**Re: Docket LC 66: Portland General Electric's 2016 IRP**

Sierra Club submits the following preliminary comments on Portland General Electric's Draft 2016 IRP. These comments were prepared with technical assistance from Tyler Comings and Ariel Horowitz of Synapse Energy Economics, Inc. As with other Oregon IRP processes Sierra Club has participated in, we focus on the overarching goal of achieving transparent resource planning that strikes a balance between low costs and risk mitigation.

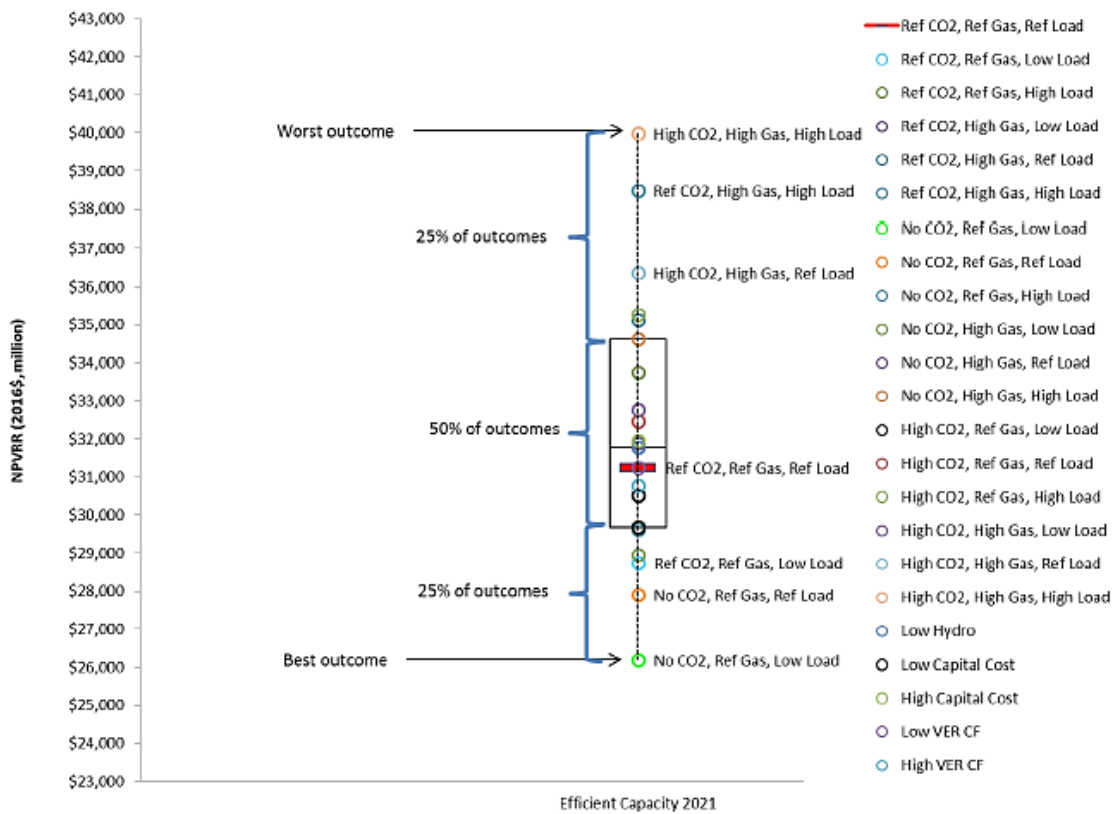
PGE developed portfolios of pre-determined resource mixes which generally meet energy and capacity obligations while also complying with the Oregon Renewable Portfolio Standard (RPS). PGE then tested these portfolios under “futures” to determine the net present value of revenue requirements (NPVRR) under different conditions—focusing on variations of carbon, natural gas, and load forecasts. However, while the mix of specific resources changes between portfolios, the bulk of the Company’s new capacity is comprised of proxy resources. While the Company asserted that it can procure a mix of resource types to fill these positions (for example, a mix of thermal and hydropower as well as seasonal or long-term contracts), PGE instead chose to model these proxies as natural gas-fired resources only. These come in the form of natural gas combined-cycle (labeled “efficient capacity”) or combustion turbine (labeled “generic capacity”) units.

PGE did not conduct full “capacity expansion” modeling to form its candidate resource portfolios. These types of models are important because they review customer peak and energy demand, as well as current and projected resources, and build resources as required to meet those demands at lowest possible cost. Key conditions—such as natural gas and carbon prices—will affect not only how often existing resources are operated but also what capacity is added or retired. In turn, those changes affect the market prices of energy that PGE would buy or sell. For instance, if a utility knew that natural gas prices were going to skyrocket, it might think twice about planning to build a new natural gas generator. Typically, capacity expansion models are populated with a large number of supply-side (and sometimes demand-side) resources, and allowed to choose the least-cost mix of resources. Had the Company conducted this type of modeling, it could have rigorously tested the portfolio mix selected by the optimization model against different market conditions. Instead, the Company’s portfolios are pre-determined, and much of the capacity added is little more than filler—modeled as natural gas combustion turbines (CT) or natural gas combined-cycle units (CC).

The Company’s methodology is flawed because it does not take into account the full range of resources available to the Company, nor does it provide an indication which of the resources that might fall into the category of “generic” or “efficient” capacity are actually cost-effective. The Company assumes that retiring existing capacity (e.g. Boardman) would necessitate new natural gas construction, mostly ignoring the alternative of procuring existing resources, either outright or through power purchase agreements (PPAs). When capacity resources are not needed in the immediate future, the possibility of procuring other types of new resources should be incorporated into the scenario modeling. PGE’s approach also does not allow for capacity to change with market conditions. As it stands, PGE is falsely limiting its

options. We recommend that the PGE conduct capacity expansion modeling to provide the Company with a more meaningful example of what it should be pursuing.
